Access Compliance Report

Public Rights-of-Way

Intersection ID: 10015389	Main Street: CALDWELL_FOREST_DR	Cross Street: N/A	Location: S
ADA ID: C775EAE6F313	Ramp Type: PerpDiag	Initial Pass/Fail: Fail	Overall Compliance: No
			Severity Score: 36.25

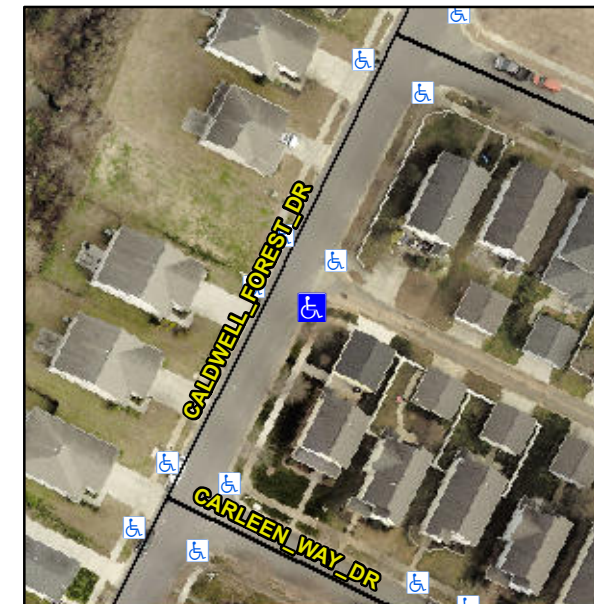
Not Found, R304.5.1, R304.5.3

Compliance	Description	Data	Compliance	Description	Data
N/A	Ramp Length (in)	63.0	Yes	Ramp Slope (%)	6.7
No	Ramp Width (in)	29.0	No	Ramp XSlope (%)	2.2
N/A	Flare Type LT	N/A	N/A	Flare Type RT	N/A
N/A	Flare Slope LT (%)	N/A	N/A	Flare Slope RT (%)	N/A
N/A	Flare Traversable LT?	N/A	N/A	Flare Traversable RT?	N/A
N/A	Landing Length (in)	N/A	N/A	DWS Provided?	N/A
N/A	Landing Width (in)	N/A	N/A	DWS Contrast?	N/A
N/A	Landing Slope (%)	N/A	N/A	DWS Length (in)	N/A
N/A	Landing X Slope (%)	N/A	N/A	DWS Full Width?	N/A
N/A	Landing Curb? (Y/N)	N/A	N/A	DWS Offset (in)	N/A
N/A	Shared Landing?	N/A			
N/A	Gutter Ponding?	N/A	N/A	Gutter Slope (%)	N/A
N/A	Gutter Lip Ht (in)	N/A	N/A	Gutter X Slope (%)	N/A
N/A	Painted X Walk1?	No	N/A	Painted X Walk2?	No
	X Walk 1 Direction	To N		X Walk 2 Direction	To W
N/A	X Walk 1 Width (in)	N/A	N/A	X Walk 2 Width (in)	N/A
	X Walk 1 Slope (%)	0.5		X Walk 2 Slope (%)	1.8
	X Walk 1 X Slope (%)	0.9		X Walk 2 X Slope (%)	1.5

Remove & Replace Curb Ramp With Two New Directional Ramps or Equivalent.
